**NOTICE OF ADDENDUM
ADDENDUM NO. 2**

**CONTRACT NO. 7939
MADISON MUNICIPAL BUILDING - RENOVATION**

This addendum is issued to modify, explain or correct the original Drawings, Specifications, or Contract Documents and is hereby made a part of the contract documents.

BE356.1

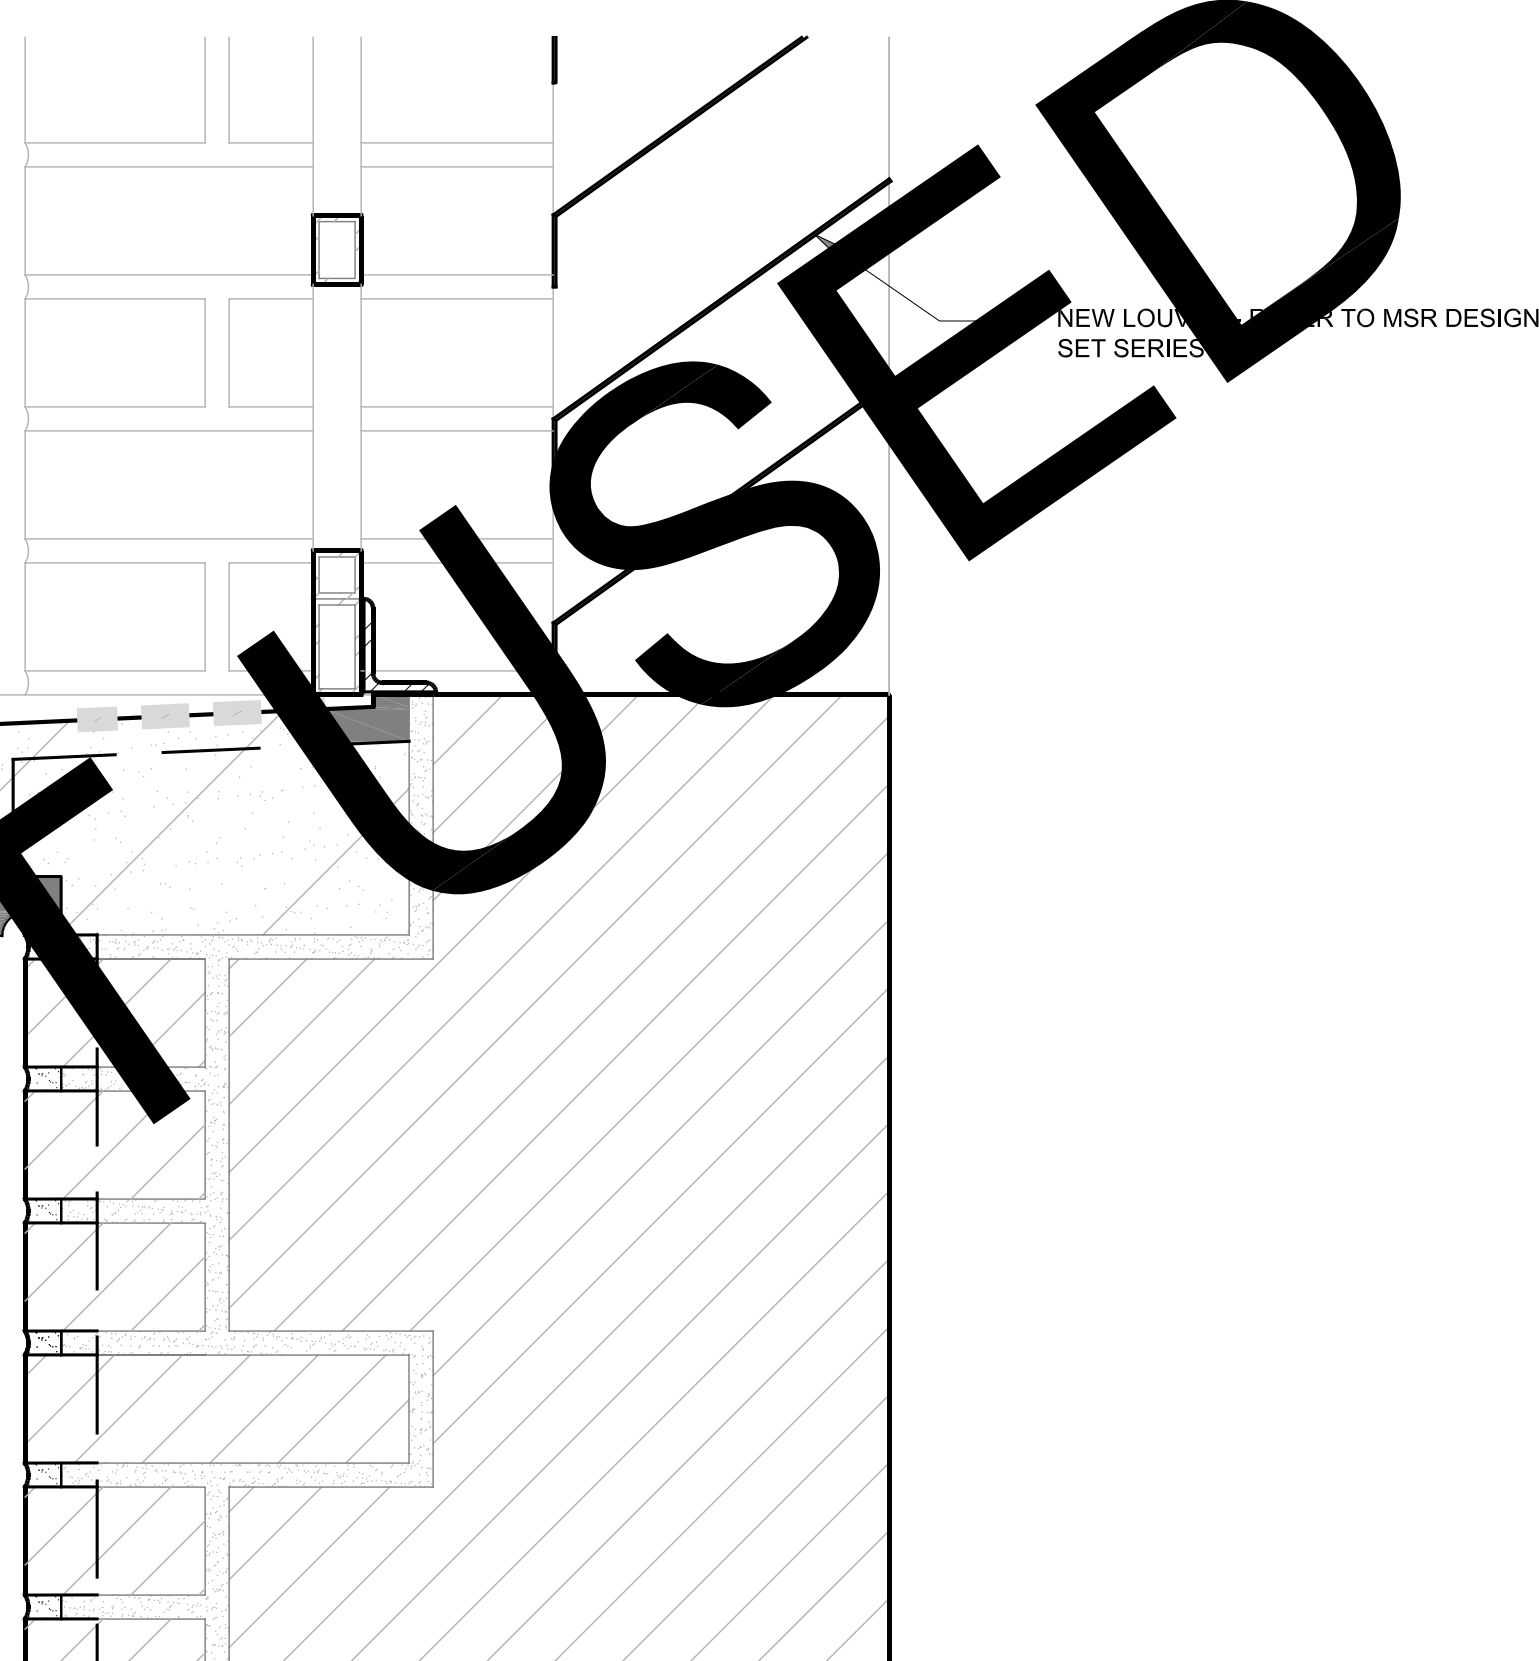
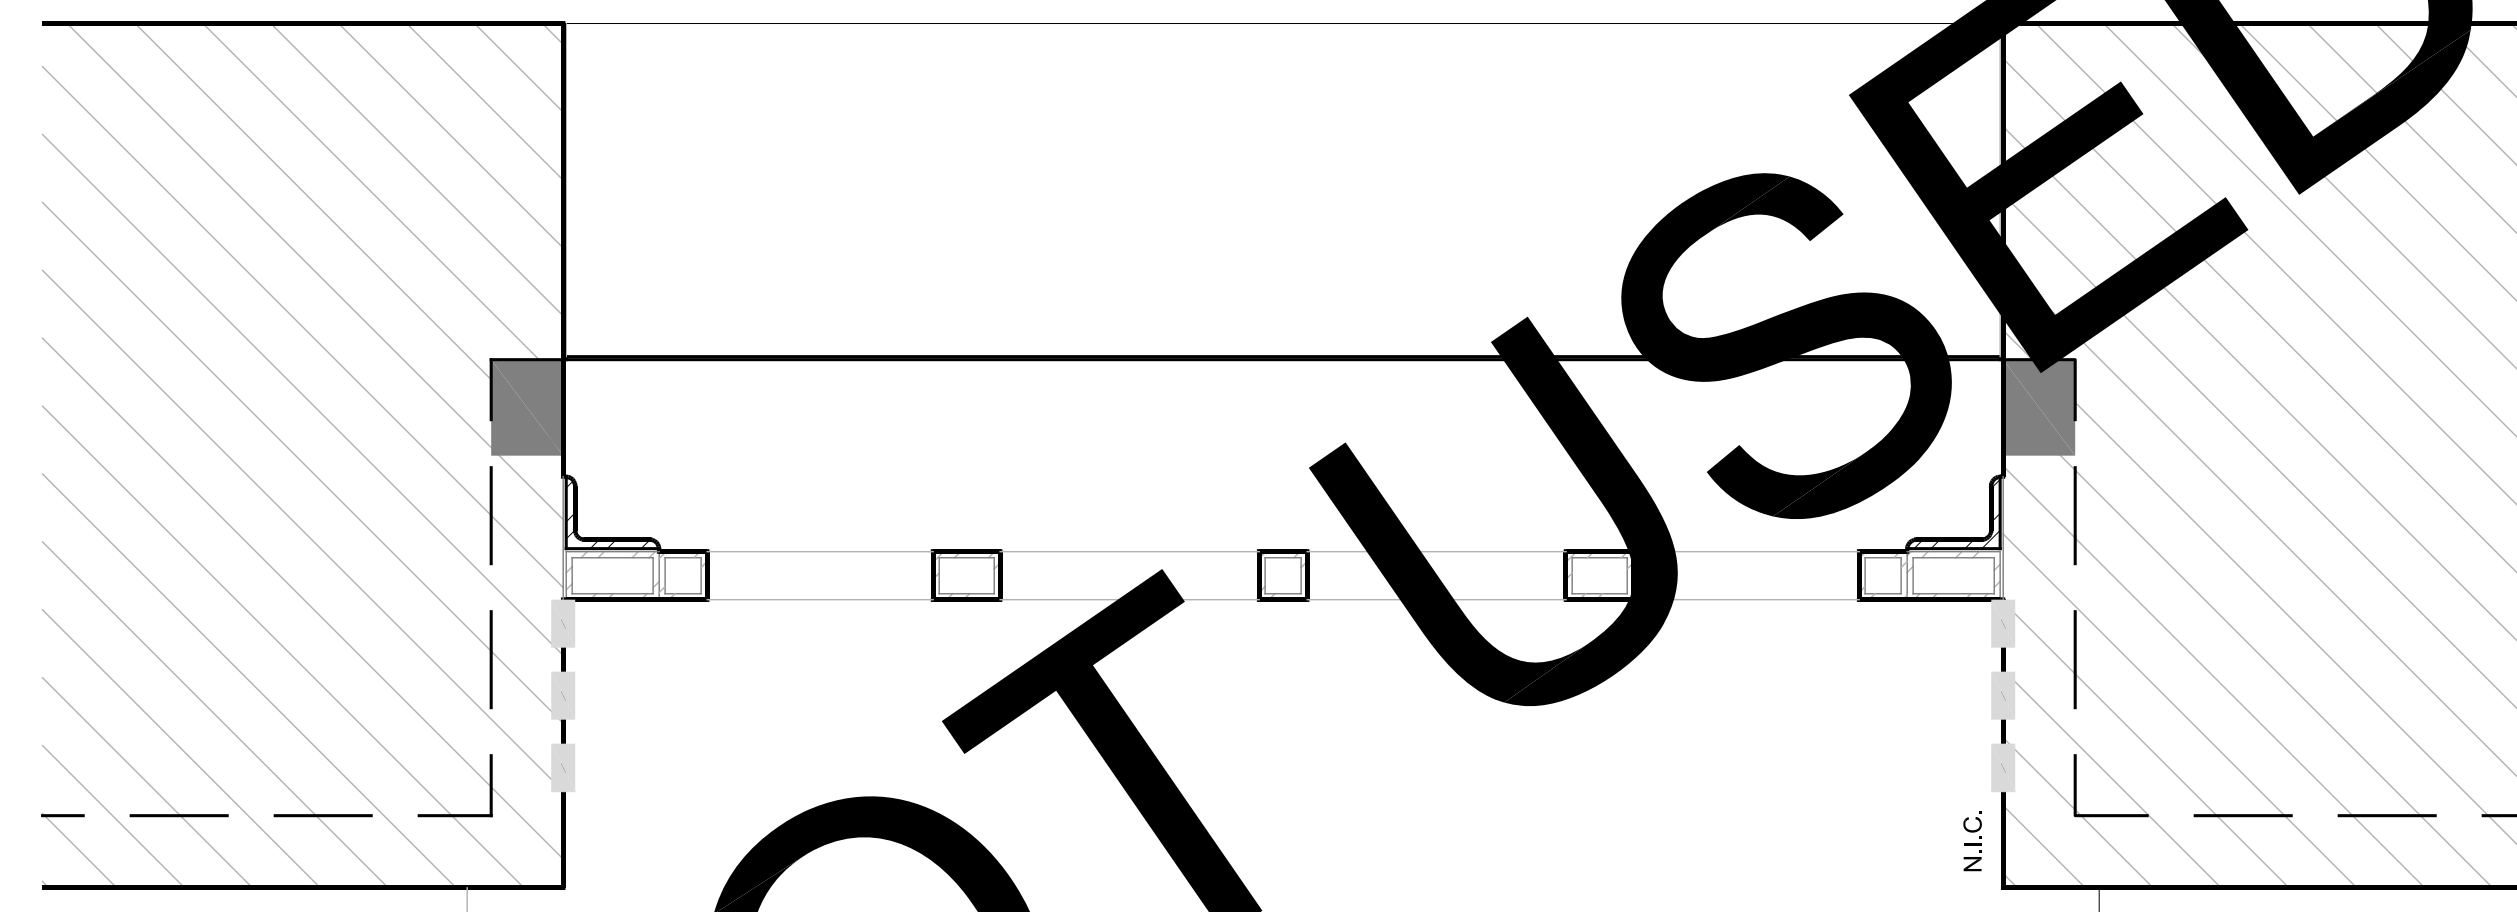
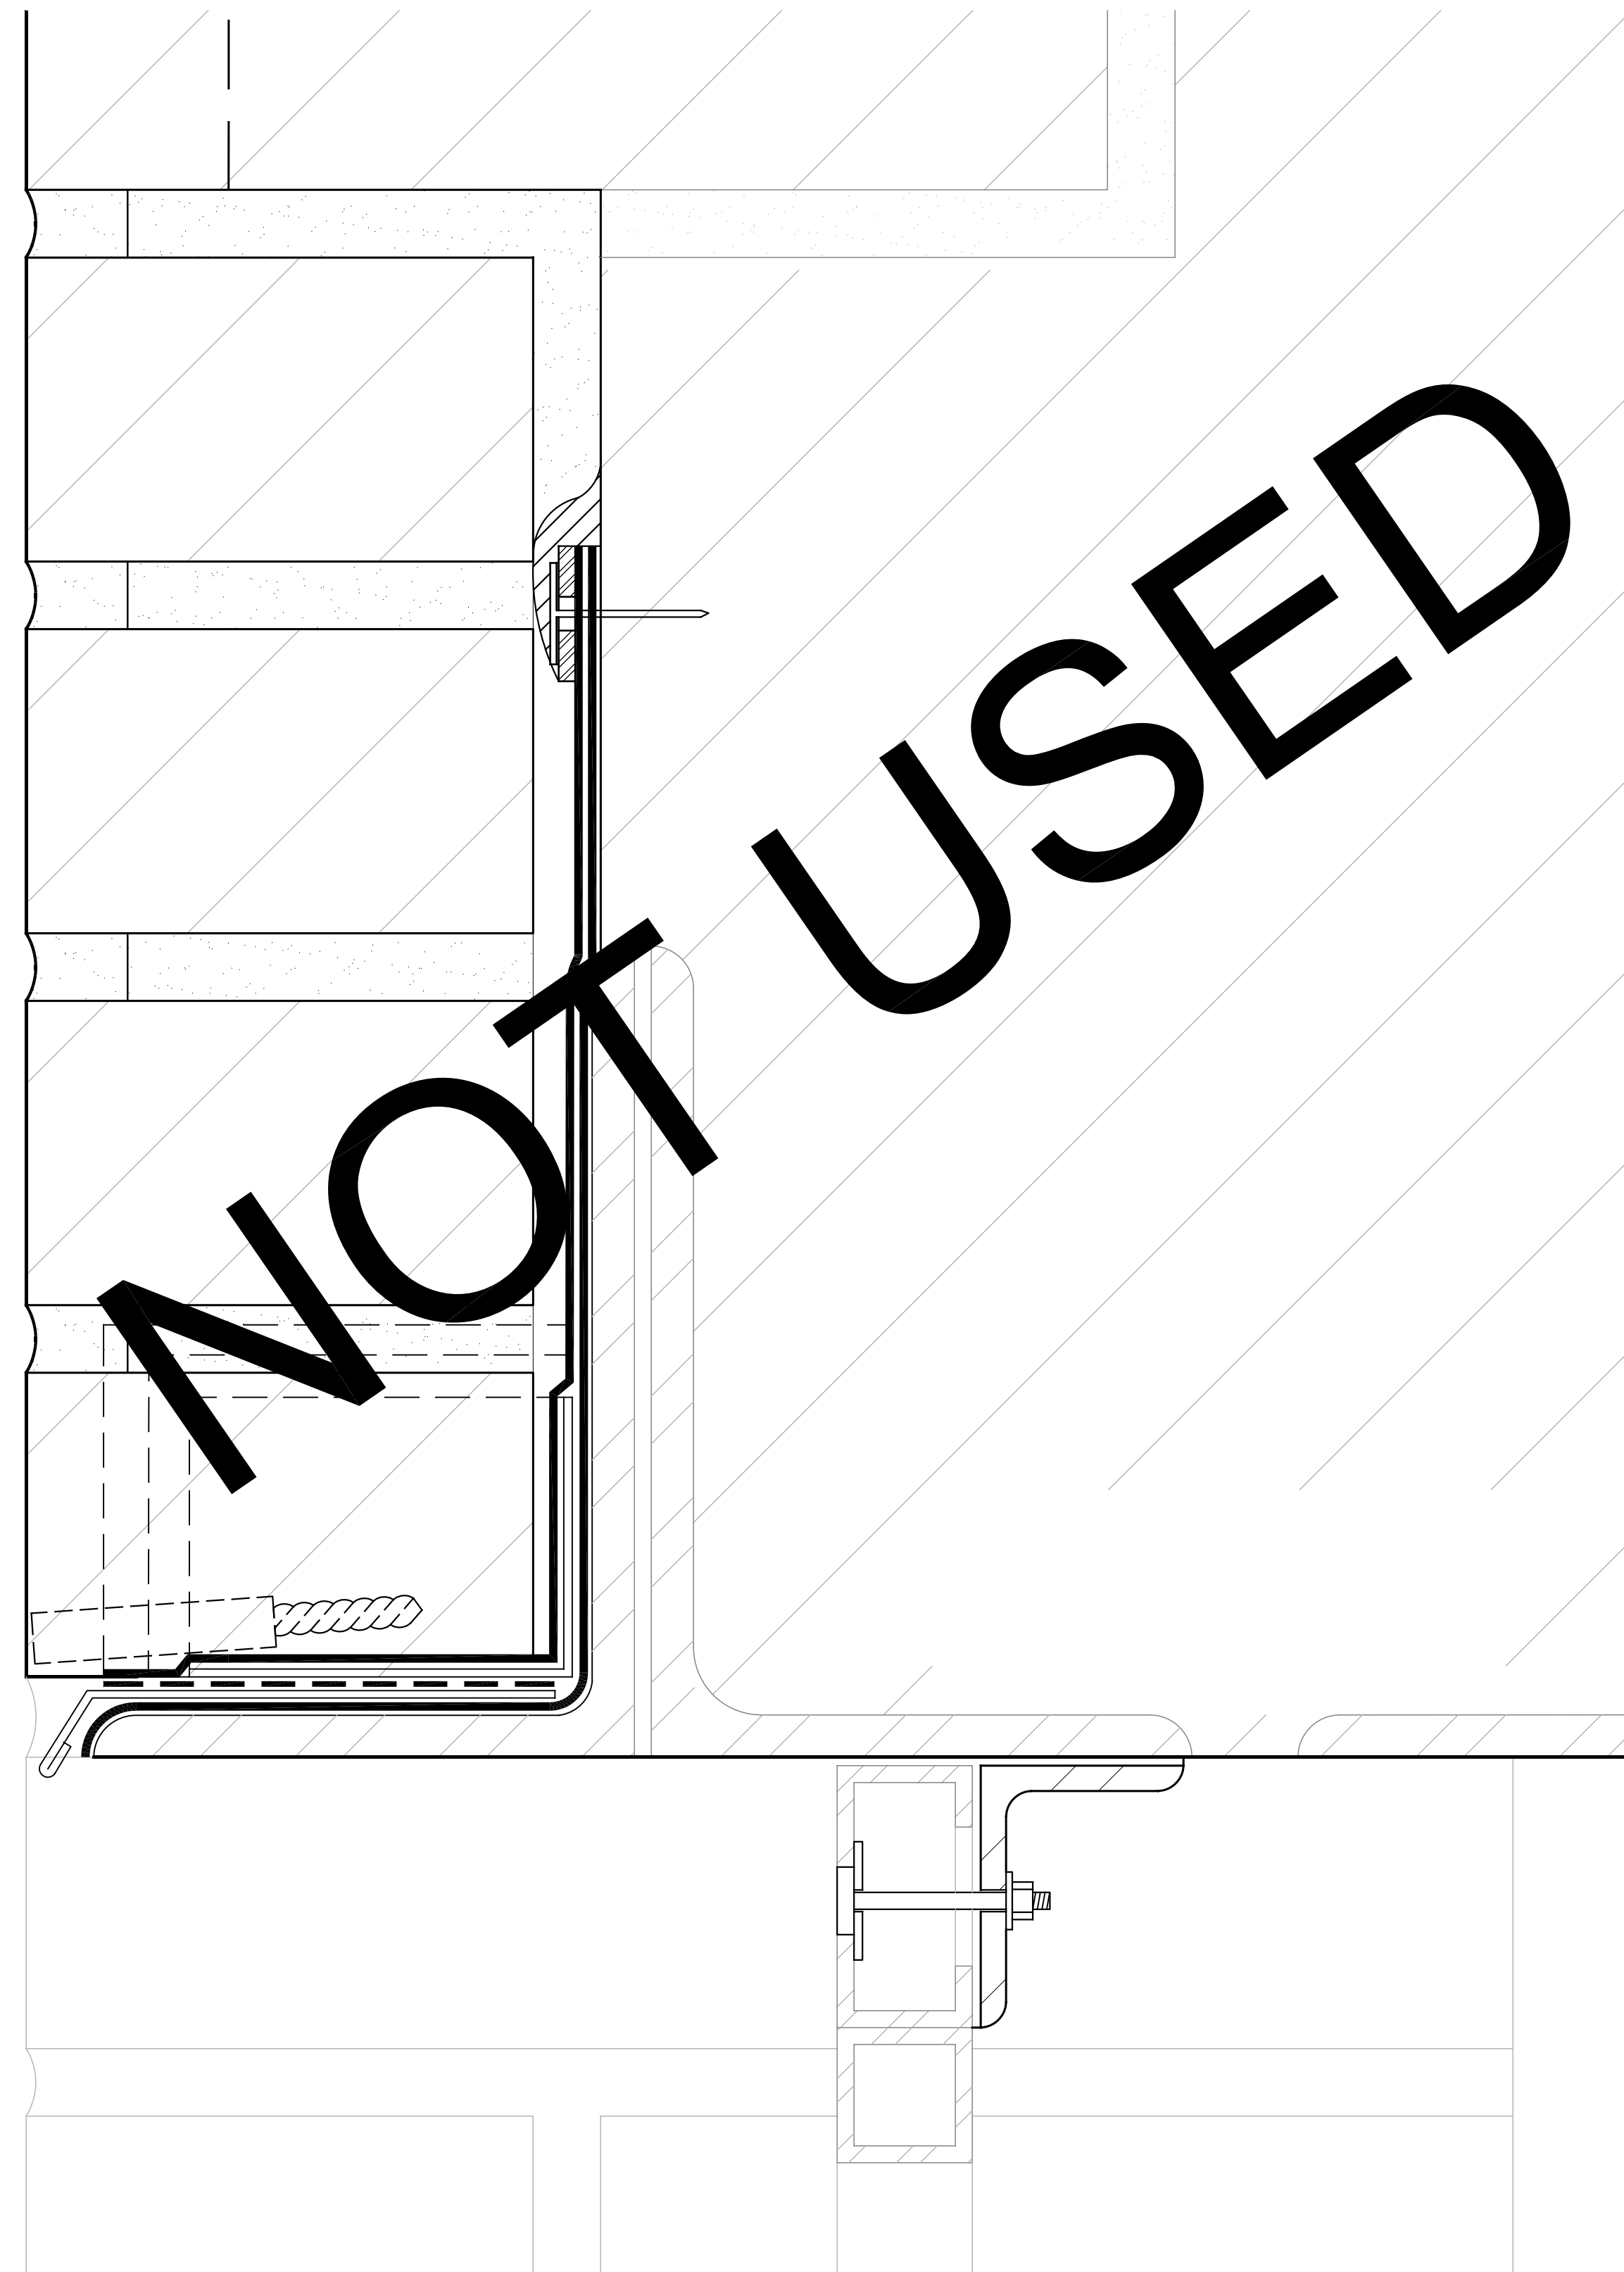
Answer: See revised Exhibit G attached with this Addendum.
14. **Question:** Sheet BE356 detail 7 states to reuse existing chimney cap while detail 1/BE356.1 (and elevations on A201) state to provide a new cap. Please clarify if we are to reuse or provide a new chimney cap.

NOTE: IN LIEU OF PREVIOUSLY DESCRIBED WORK - CHIMNEY SCOPE SHALL ONLY CONSIST OF NEW LEAD CAP FLASHING ON THE EXISTING CHIMNEY CAP
